BEFORE THE MERIDIAN CITY COUNCIL

IN THE MATTER OF THE)
REQUEST FOR FINAL PLAT)
CONSISTING OF 54 BUILDING) CASE NO. FP-2021-0052
LOTS AND 14 COMMON LOTS ON)
16.06 ACRES OF LAND IN THE R-8	ORDER OF CONDITIONAL
ZONING DISTRICT FOR GANDER) APPROVAL OF FINAL PLAT
CREEK NORTH SUBDIVISION NO.)
3.)
)
BY: KENT BROWN PLANNING)
SERVICES)
APPLICANT)
)

STAFF REPORT

Gander Creek North Subdivision No. 3

B. Final Plat (not dated)

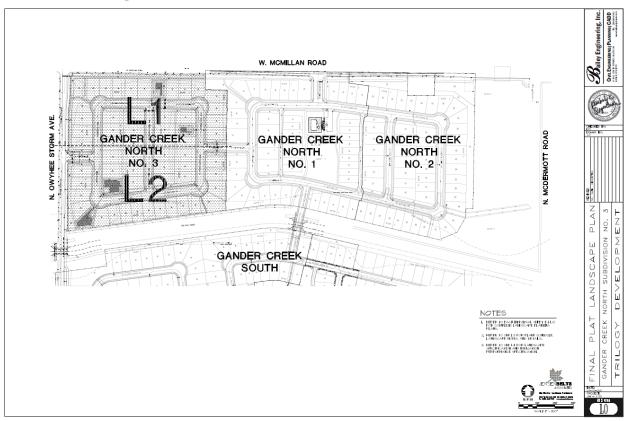
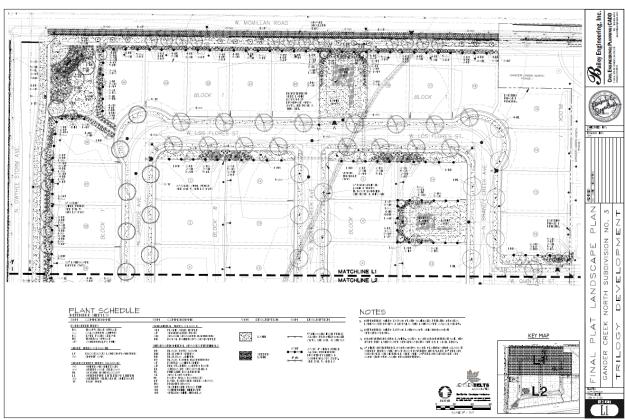
- 3. Prior to submittal for the City Engineer's signature, have the Certificate of Owners and the accompanying acknowledgement signed and notarized.
- 4. The final plat prepared by Bailey Engineering, Inc. by Gregory G. Carter, included in Section V.B shall be revised as follows:

- a. Note #10: Include the recorded Instrument Number for the ACHD Permanent Easement.
 - b. Note #11: Include the recorded Instrument Number of the ACHD License Agreement.

- c. The professional land surveyor shall affix their signature and date to the face of the plat sheets.
 - d. Include the recorded Book and Page numbers of the Gander Creek North Subdivision No. 1 referenced on Sheet 1 of the plat.

C. Landscape Plan (dated: 07/19/2021)

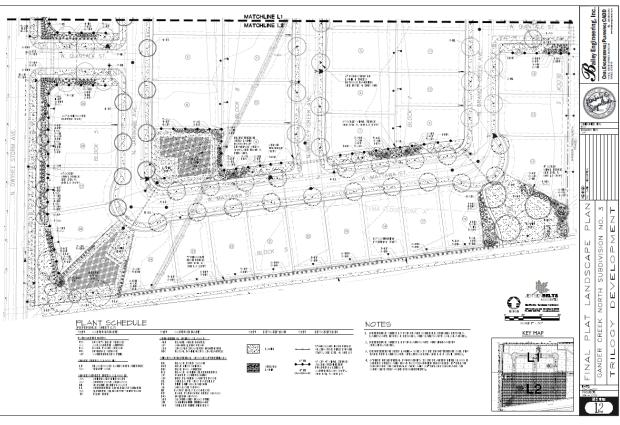
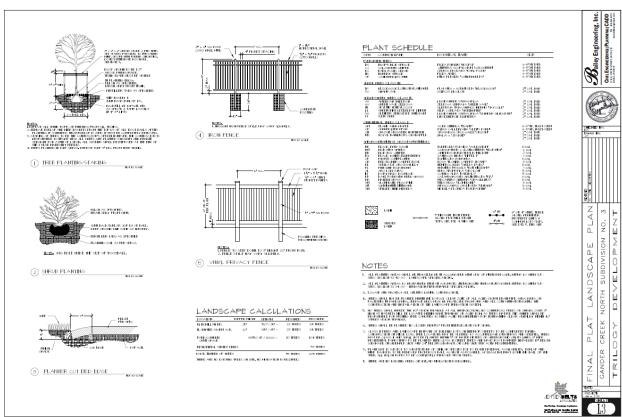
- 5. The landscape plan prepared by Jensen Belts Associates, dated 09/20/2021, included in Section V.C. shall be revised as follows:
 - a. A minimum of one (1) tree per 100 linear feet of pathway is required adjacent the multi-use pathway along the Five Mile Creek as set forth in UDC 11-3B-12C.2. *If NMID doesn't allow trees within their easement on their property, a common lot should be provided on the subject property to accommodate the landscaping.*

- b. In the Landscape Calculations table, include the required vs. provided number of trees along pathways that demonstrate compliance with UDC 11-3B-12C.2.
